APPLICATION NO.	F	TILING DATE	FIRST NAMED INVENTOR	ATTORNEY DOCKET NO.	CONFIRMATION NO.	
10/766,391	10/766,391 01/28/2004		Douglas Dombrowski	DP-311282	3331	
22851	7590	07/15/2005		EXAM	EXAMINER	
DELPHI TECHNOLOGIES, INC.			LUONG, VINH			
M/C 480-410 PO BOX 500				ART UNIT	PAPER NUMBER	
	OY, MI 48007			3682		
				DATE MAILED: 07/15/2005	5

- (b) the invention was patented or described in a printed publication in this or a foreign country or in public use or on sale in this country, more than one year prior to the date of application for patent in the United States.
- 3. Claims 1-7 are rejected under 35 U.S.C. 102(b) as being anticipated by Heling (US Patent No. 4,607,884).

ATTACHMENT

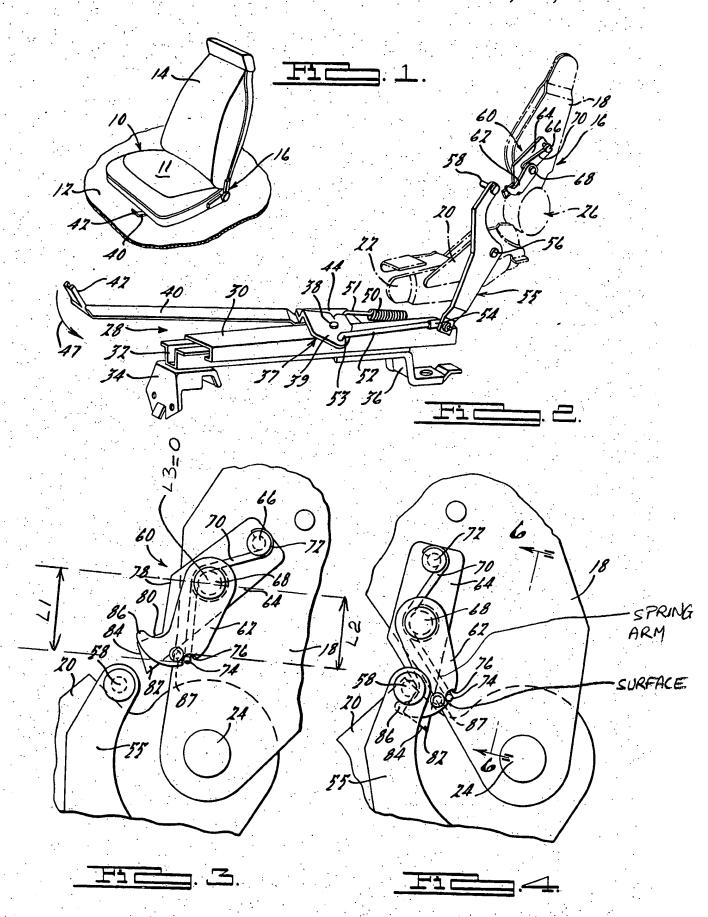
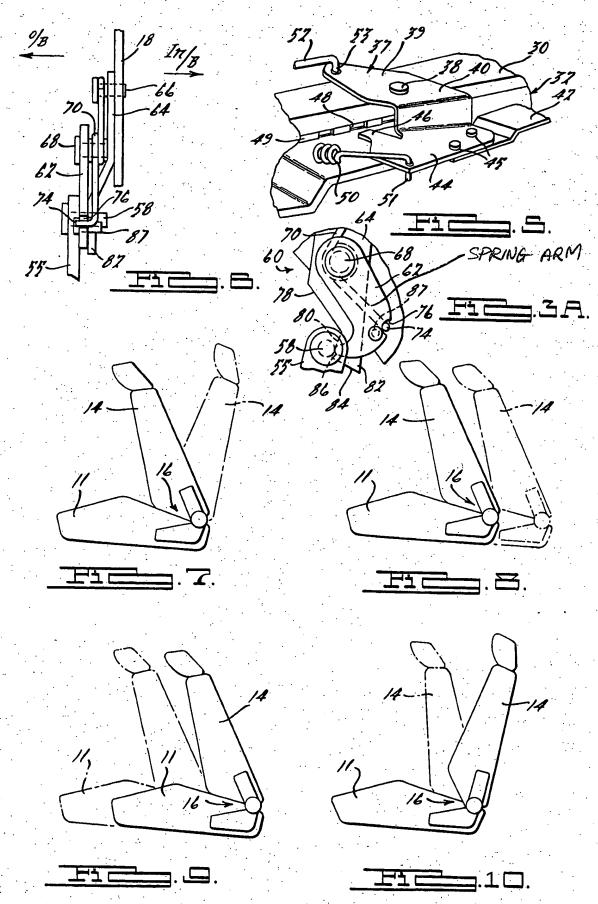
Regarding claim 1, Heling teaches a two position, spring biased lever system comprising a lever 62 that pivots on a support 68 between a first position (Fig. 3 or 3A) and a second position (Fig. 4), and a spring 70 having an arm (unnumbered. See Attachment) that engages the lever 62 to hold the lever 62 in the first position and concurrently biases the lever 62 toward the second position.

Regarding claim 2, Heling teaches a two position, spring biased lever system comprising a lever 62 that pivots on a support 68 between a first position (Fig. 3 or 3A) and a second position (Fig. 4), said lever 62 comprising a notch 76, and a spring 70 having a spring arm (Att.) that engages the notch 76 in the lever 62 to hold the lever 62 in the first position while biasing the lever 62 toward the second position when the lever 62 is in the first position.

Regarding claim 3, Heling teaches a two position spring biased lever system comprising a lever 62 that pivots on a support 68 between a first position (Fig. 3 or 3A) and a second position (Fig. 4), said lever 62 having a notch 76, and a torsion spring 70 having a tangential spring arm (Att.) that is attached to a central coil (at 68 in Fig. 3) at one end and that has a distal end 74 engaged in a notch 76 of the lever 62, the torsion

spring 70 being stressed so that the spring arm (Att.) holds the lever 62 in the first position when the distal end 74 is in the notch 76 while biasing the lever 62 toward the second position, the spring arm (Att.) moving the lever 62 to the second position when the distal end 74 is *partially* disengaged from the notch 76 (Fig. 4).

Claim 3 is anticipated by Heling because Heling's distal end 74 is *partially* disengaged from the notch 76 when the lever 62 is moved to the second position as seen in Fig. 4. On the other hand, Heling's distal end 74 of the spring arm is capable of being disengaged from the notch 76 if the user moves the seat back 14 forwardly as seen in Figs. 7-10 with a sufficient force. See *In re Schreiber*, 44 U.S.P.Q.2d 1429 (CAFC 1997)(A reference may be from an entirely different field of endeavor than that of the claimed invention or may be directed to an entirely different problem from the one addressed by the inventor, yet the reference will still anticipate if it explicitly or inherently discloses every limitation recited in the claims).

Regarding claim 4, the distal end 74 of the spring arm (Att.) when *partially* released from the notch 76 slides along a surface (Att.) of the lever 62 to bias the lever 62 to the second position.

Regarding claim 5, the distal end 74 of the spring arm 70 is a *substantially* perpendicular end portion of the spring arm (Att.), which when *partially* released from the notch 76 slides along a surface (Att.) of the lever 62 to bias the lever 62 to the second position.

Regarding claims 6 and 7, the spring arm (Att.) has a length L-1 (Att.) measured from its pivot to the distal end, wherein the lever has a length L-2 (Att. 2) measured from its pivot to the notch, and wherein the system has a length L-3 measured

from the pivot of the spring arm to the pivot of the lever (L-3 = 0 because the pivot of the spring arm coincides with the pivot of the lever) and wherein the sum of the length L-1 and the length L-2 exceeds the length L-3 (which is equal to zero) when the lever is in the first position as seen in Fig. 3 or 3A.
